BOARD ACTION REPORT – APPEALABLE ITEM

Project Name: Bahia Delray
Project Location: 1001 Crystal Way
Request: Class IV Site Plan Modification consisting of the site plan, architectural elevations, and landscape plan.

Board: Site Plan Review and Appearance Board

---STAFF REPORT---

PROPOSED COMPOSITE SITE PLAN

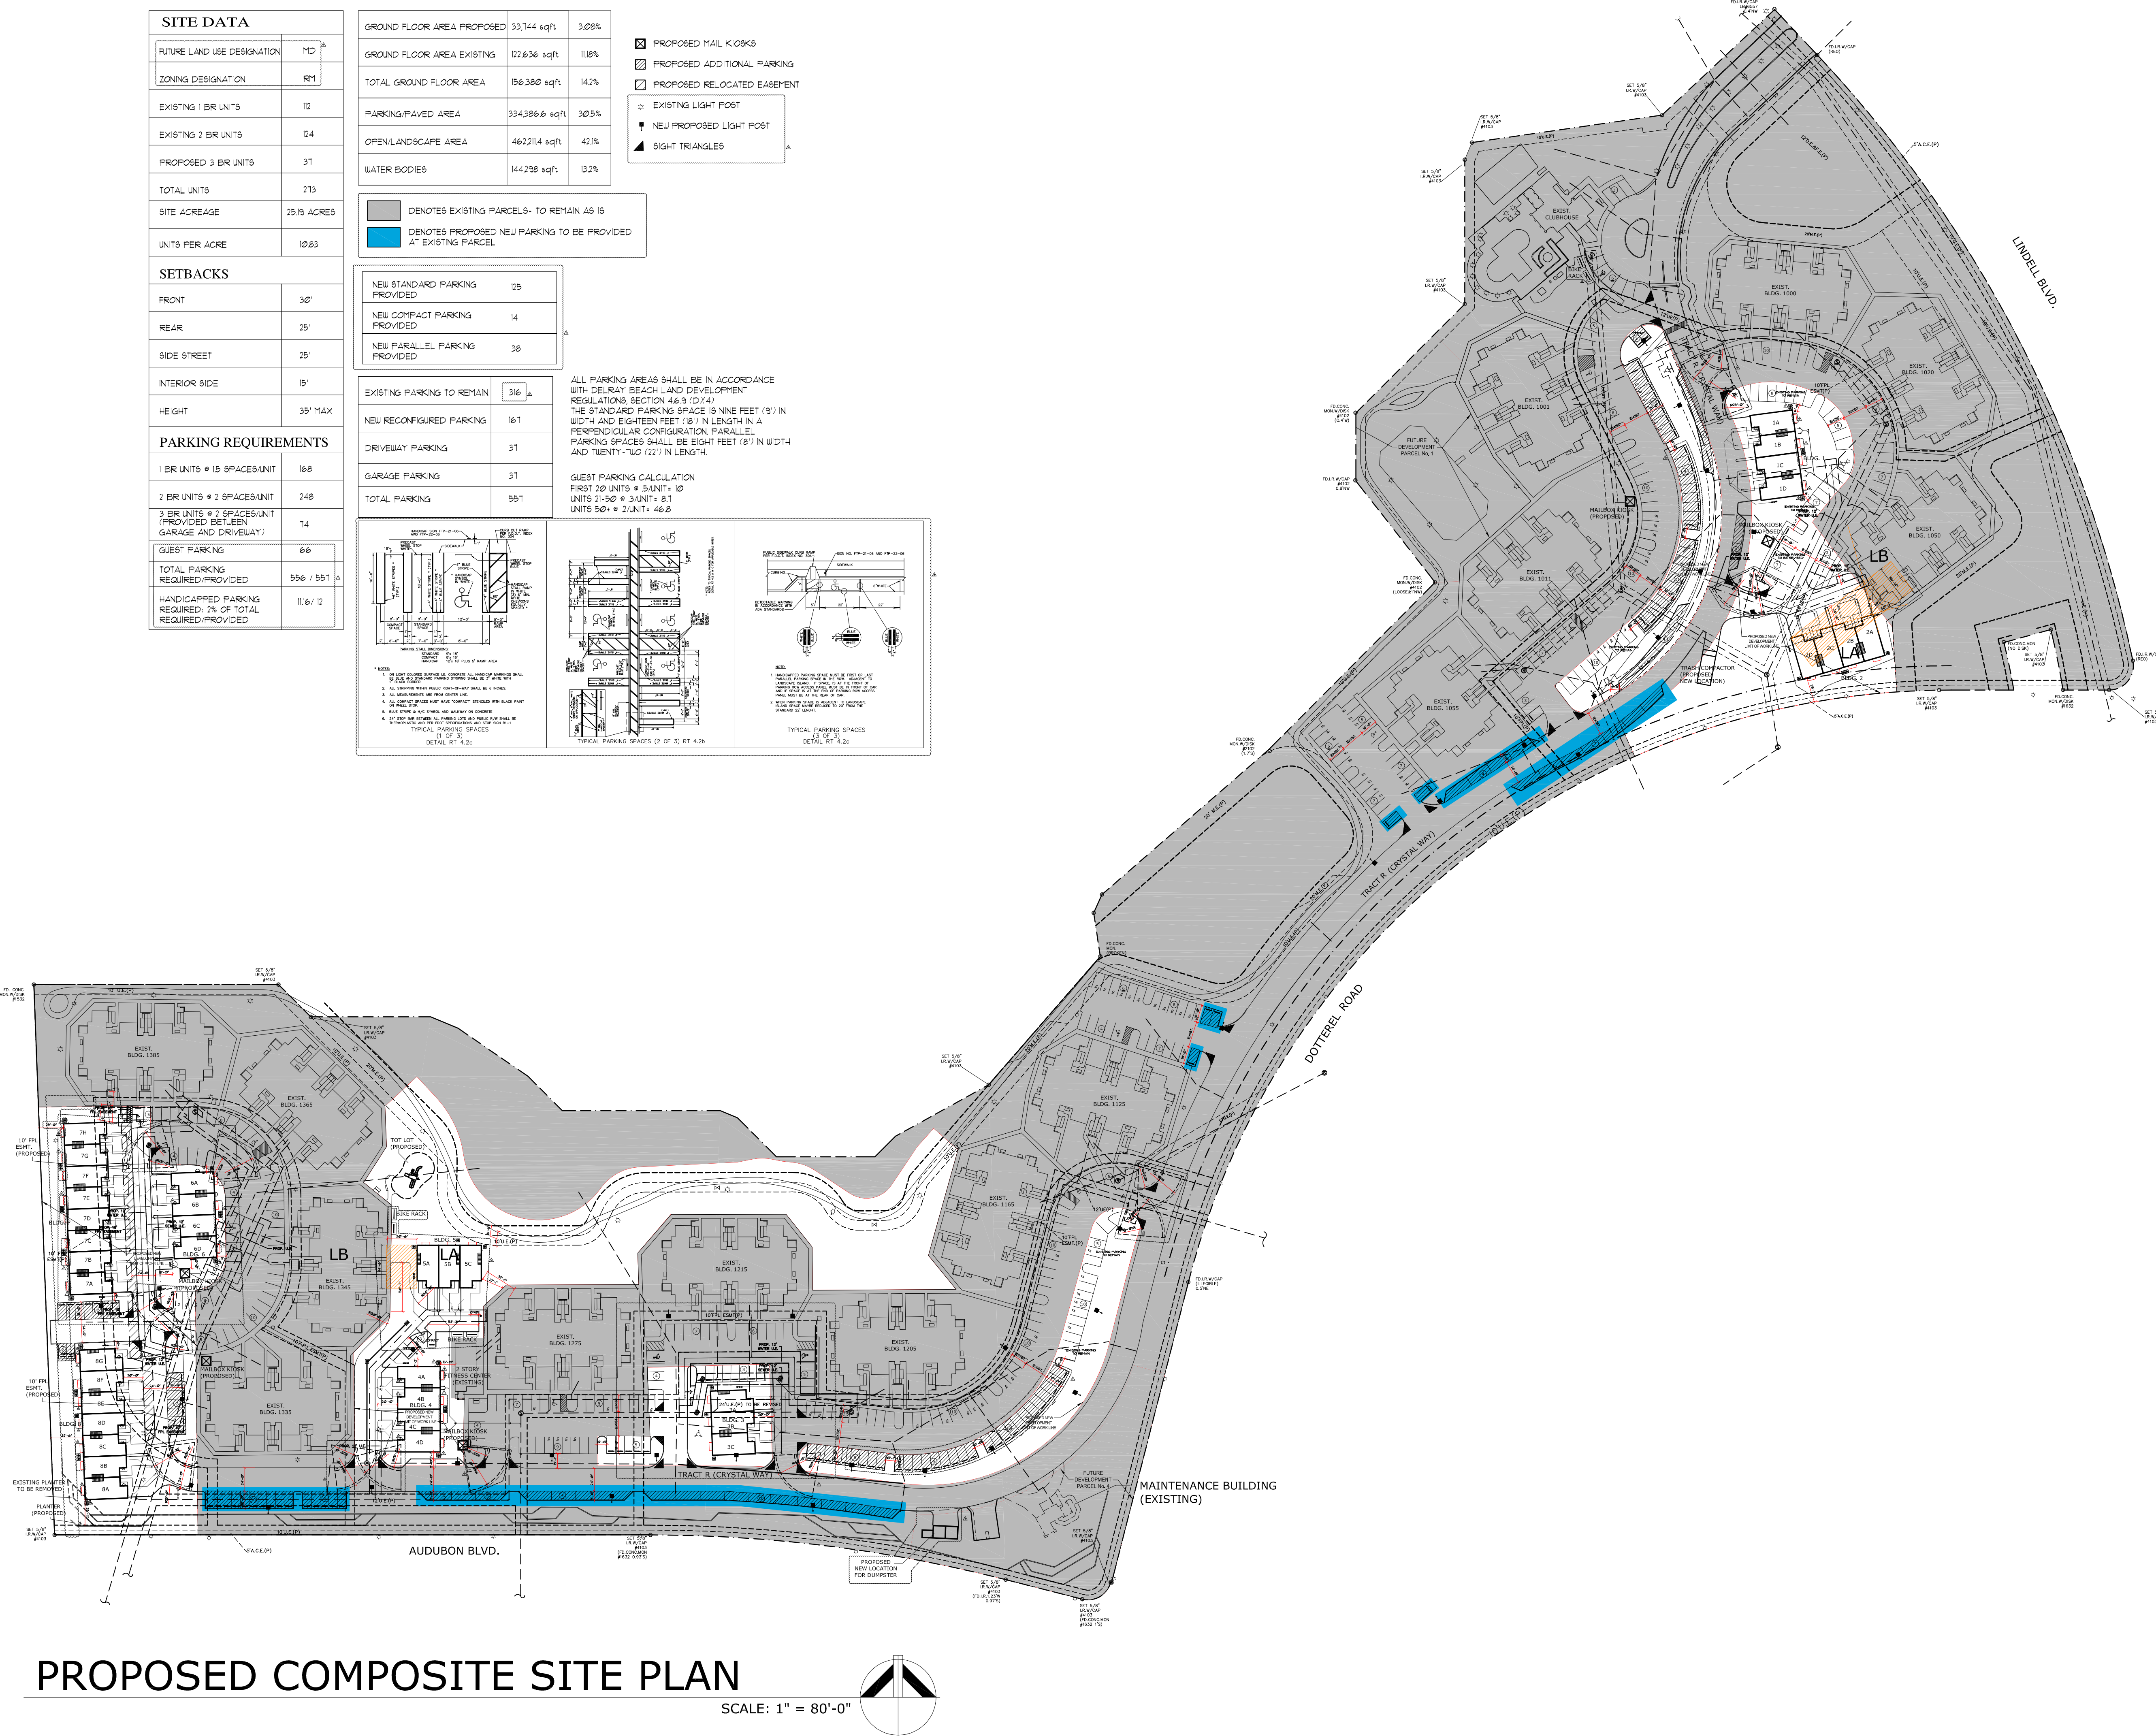
Site Plan: Approve subject to the conditions that all plans are revised to illustrate preservation of Tree #194 and Tree #197, and removal of the associated/proposed parking spaces.

- Site Plan: 1. That the driveways and walkways for the units not be finished with asphalt; 2. That the transformer pads are noted on the plans; 3. That the photometric plan include lighting levels for the roadways and driveways throughout the property.
- Landscape Plan: 1. That the application be thoroughly reviewed again by Peter Anuar, Senior Landscape Planner, to see if more trees can be saved.

A Live Oak (Tree #194) has been identified as a candidate to remain in location, as opposed to being relocated. The tree is located to the west of Building #3. For the tree to remain on site, however, two parking spaces will be eliminated, as permitted by the subject LDR Section. While Staff is supportive of this substitution, Board approval is required with the condition that revised plans are provided.
